REGIONAL REVIEW NOTIFICATION

ARC REVIEW CODE: R1712181

Name of Proposal: Emerson Center (DRI 2764)

EMERSON CENTER DRI
City of Smyrna
Natural Resources Group Review Comments
December 13, 2017

DRI SITE PLAN
EMERSON CENTER
LAND LOTS 880 & 881
17th DISTRICT, 2nd SECTION
COBB COUNTY GEORGIA

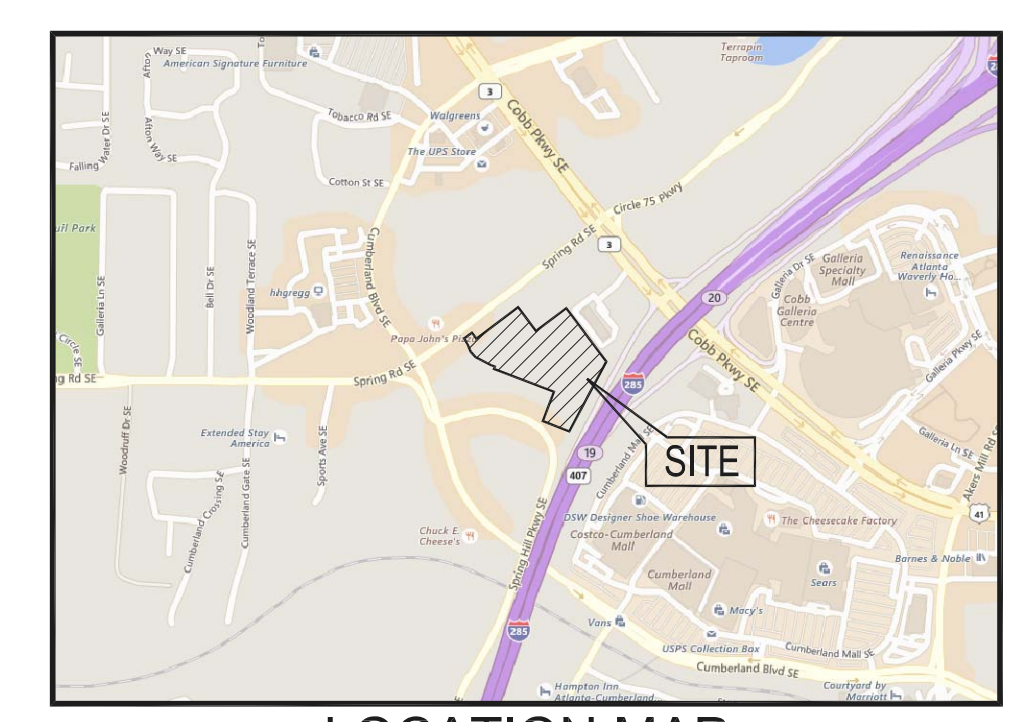
Pedestrian facilities are currently available along existing roadways allowing for safe accessibility. The site plan does not provide information regarding pedestrian and bicycle facilities.

The site plan does not provide specific information or depictions of bicycle and pedestrian facilities. While there are opportunities vis site design to provide connectivity to adjacent parcels, the site plan does not show any proposed connections.
